TECHNICAL NOTE

DATE:	01 November 2022	CONFIDENTIALITY:	Public
SUBJECT:	Site A – Response to Drainage Officer Comments		
PROJECT:	Bognor Golf Course	AUTHOR:	Andy Smith

This Technical Note has been produced to provide a detailed response to the Drainage Officers comments on the surface water drainage strategy for Site A which was developed to support the Hallam Land Management Ltd's planning application for the redevelopment and relocation of the existing Golf Course (planning app ref: M/16/22/PL and FP/274/21/OUT).

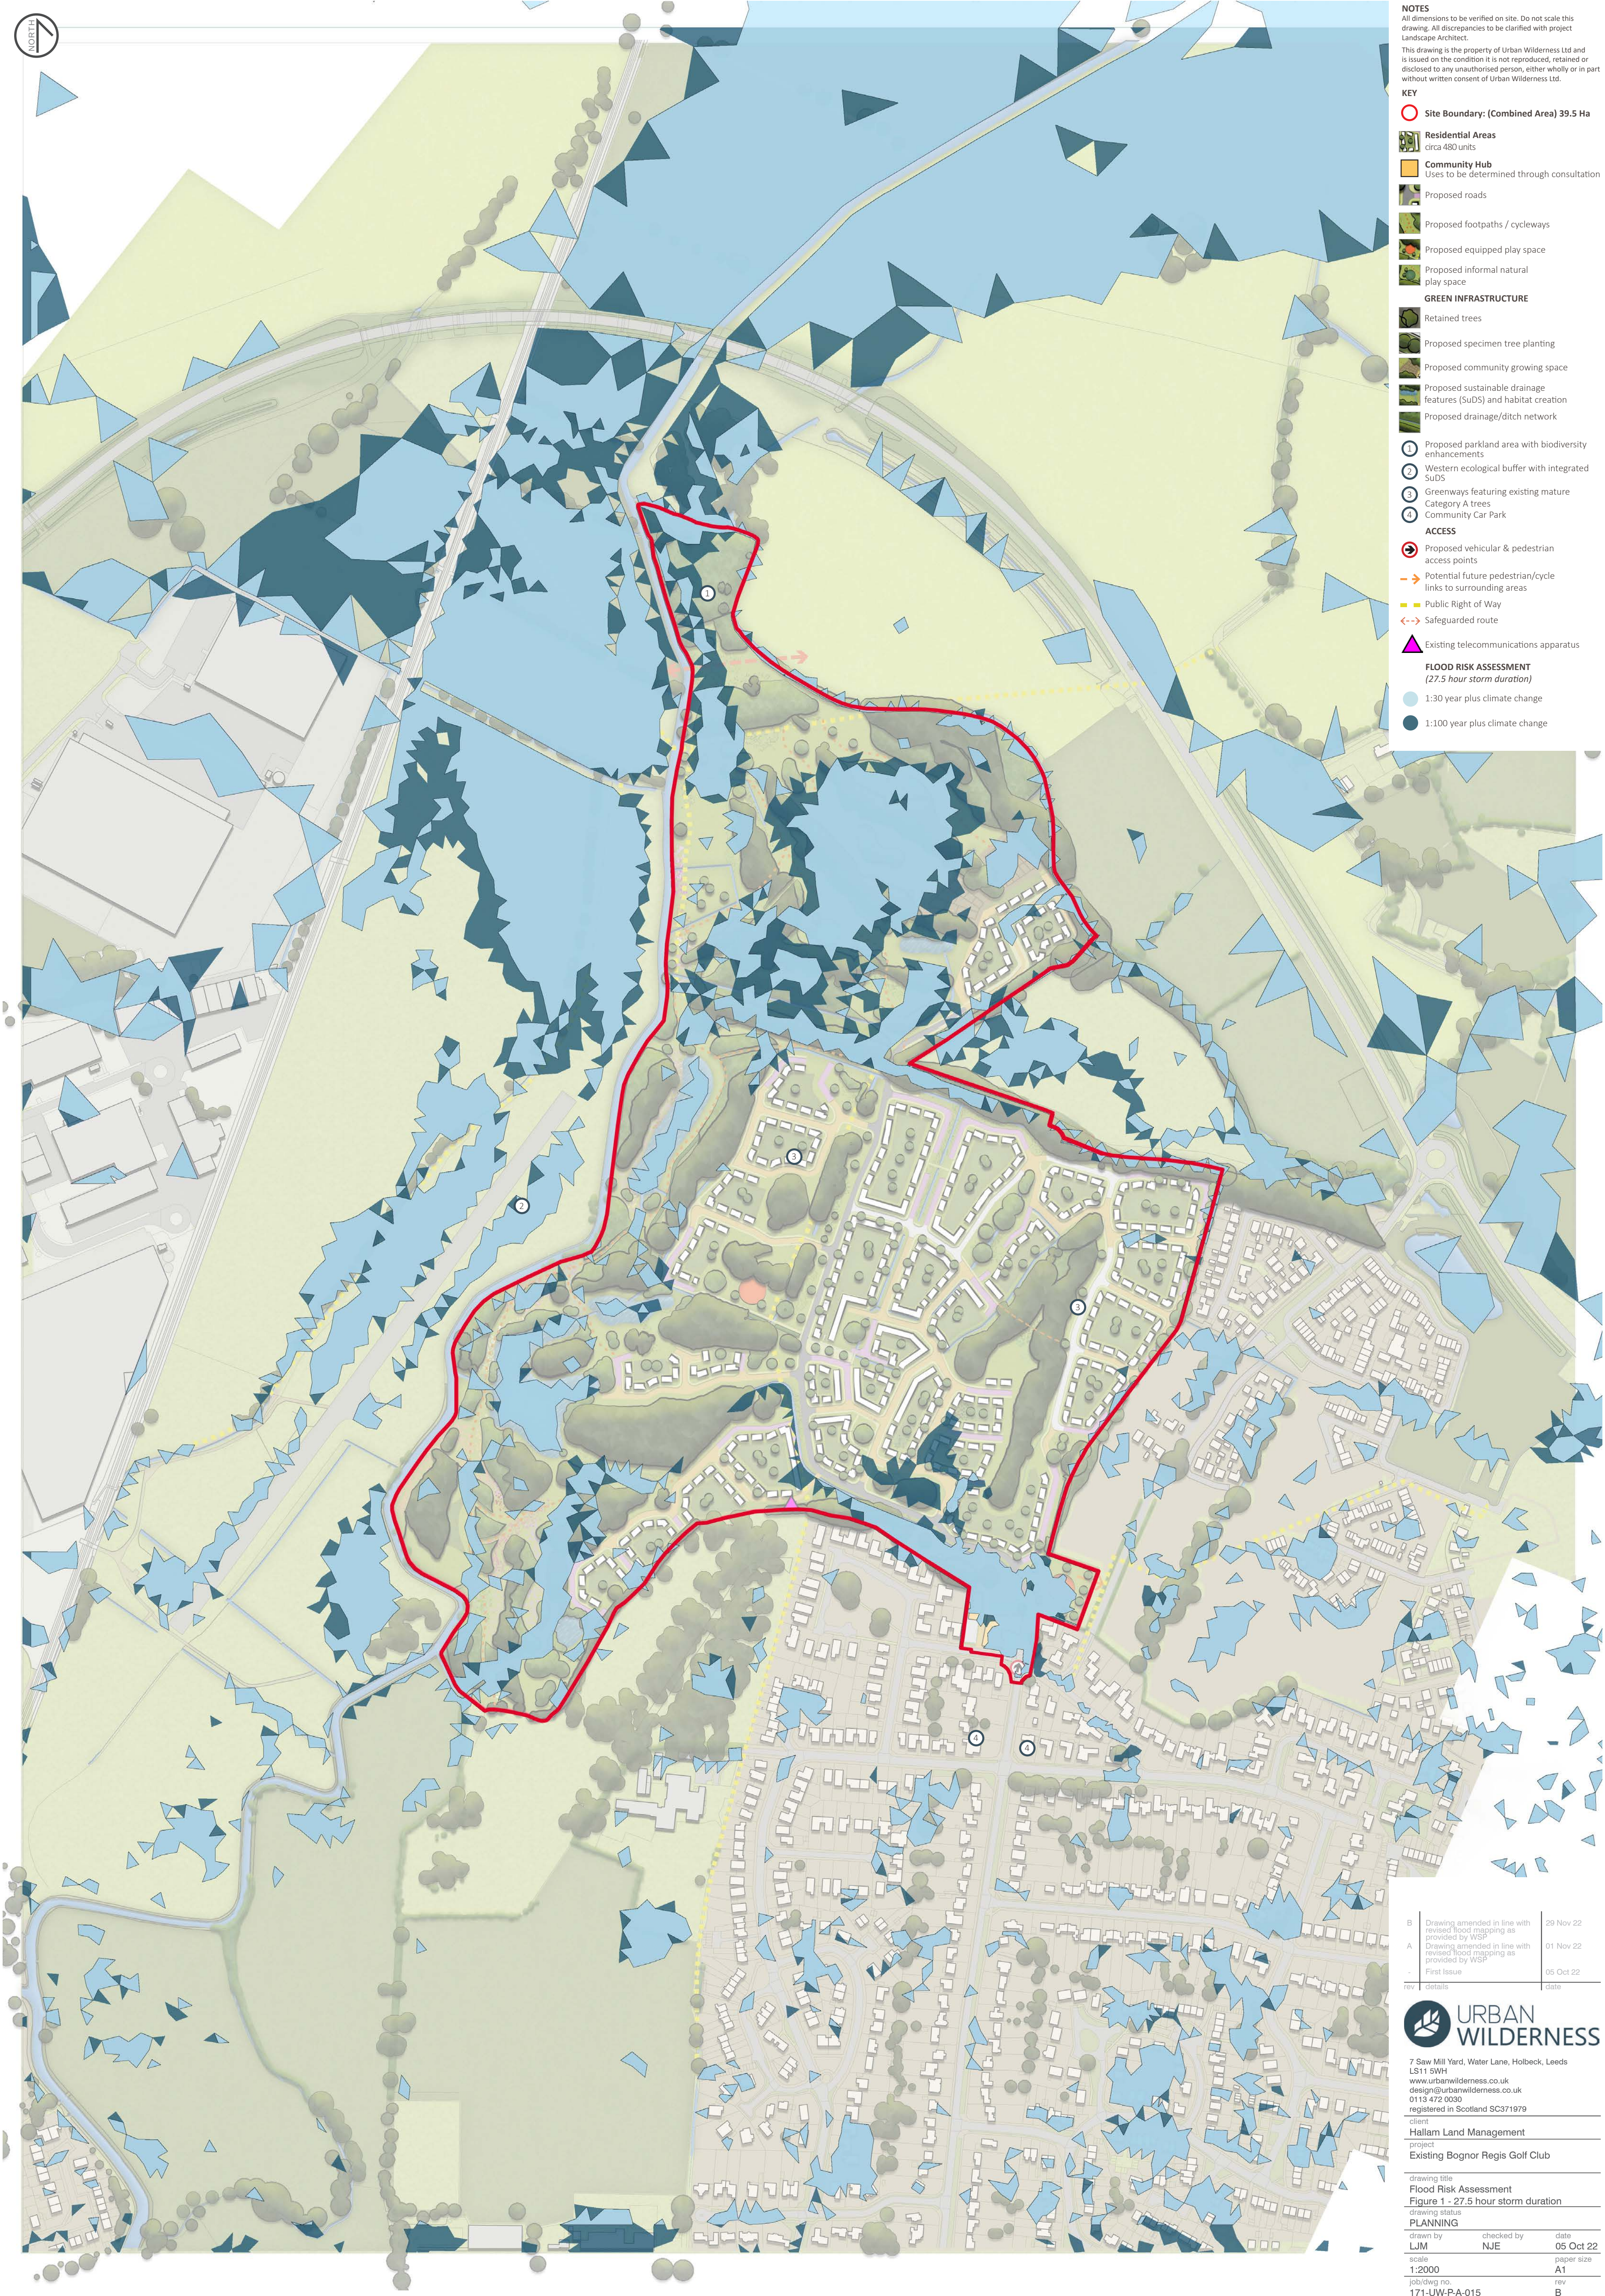
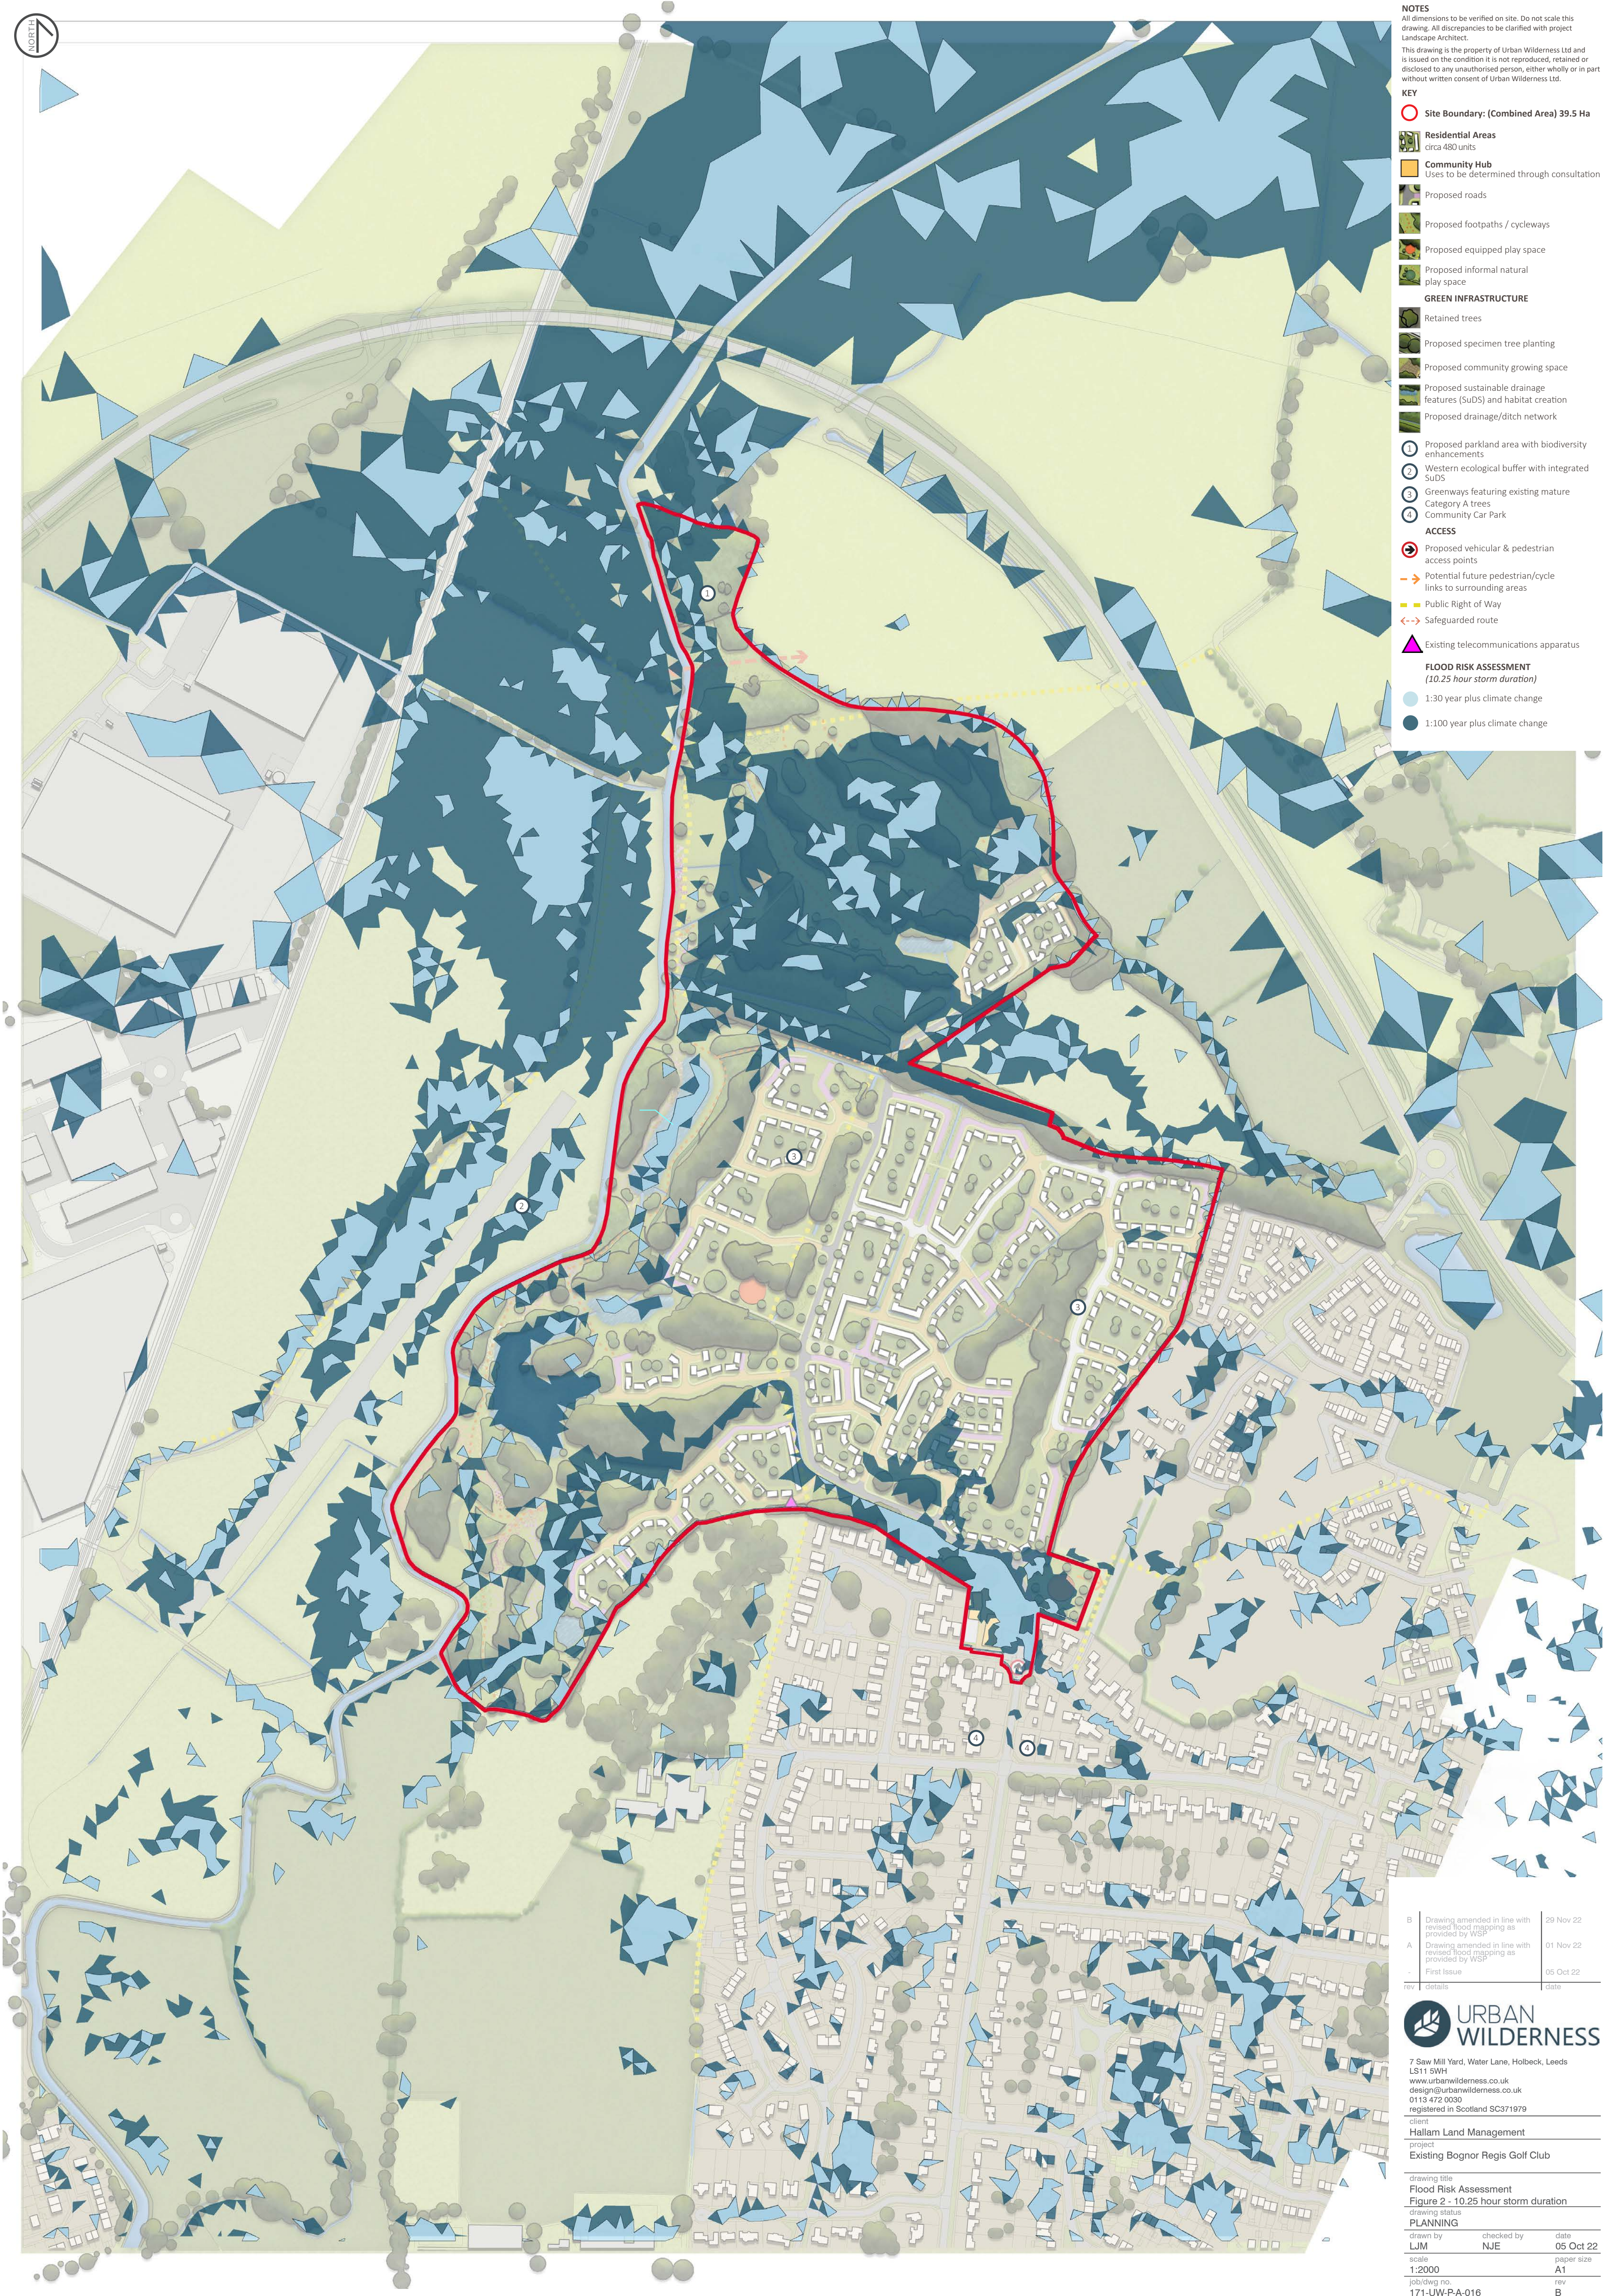
3 - No clear surface water drainage proposals are provided for either site. We appreciate that proposed 3D ground modelling is provided but more information needs to be provided on where the proposed development impermeable areas are draining to, attenuation provisions and where the surface water is ultimately being discharge to. The surface water calculations need to be provided to demonstrate that the run-off from these areas can be accommodated within the proposed attenuation features. In addition, clear information on the modelled fluvial flood level in relation to the attenuation features needs to be provided and surface water calculations need to demonstrate the impact of joint probability events. This is to ensure that the quantum of development proposed at outline stage is achievable and that the surface water drainage proposals comply in not increasing the risk of flooding elsewhere or onsite. In addition to this the locations of the proposed SuDS must clearly be outside of the impacts of the modelled fluvial flood extents.

The flood modelling, which is currently being approved by the Environment Agency (point 1) demonstrates that all the ponds (A, B, C and D) are not at risk of fluvial / pluvial flooding for the design event including the latest climate change allowances. The flood maps are appended, whilst ponds C and D are shown to be dry, water is shown to be within ponds A and B due to their size and the direct rainfall nature of the flood model which applies rainfall to the whole catchment (including the site), the result is that some water directly falls onto the ponds whereas other flows in through the ditch network.
